CERTIFICATE OF APPROPRIATENESS

Property: 620 Woodland Street, Tracts 5 & 6A, Block 27, Woodland Heights Subdivision. The property includes a historic one-story wood frame single-family residence and a detached garage situated on a 5,000 square foot (50' x 100') interior lot.

Proposal: Alteration – Replace siding and windows

PROPOSED WINDOWS

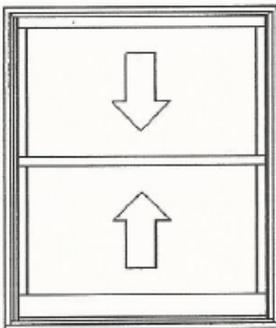
- Replace two non-original windows (B & C) on the first floor of the west wall with smaller windows.
- Patch a previously walled-over window (D) on the second floor of the west wall and remove remaining exterior trim
- Replace all siding on the west wall. Existing siding is a mix of non-original cementitious, non-original wood and original wood.

Windows/Doors: The residence features original eight-over-one wood windows and non-original one-over-one windows. All windows feature exterior wood trim. Two non-original windows and their trim will be removed and replaced with smaller double-hung wood windows and trim. A previously removed window will be covered with siding and its trim will be removed. All other windows will remain unaltered.
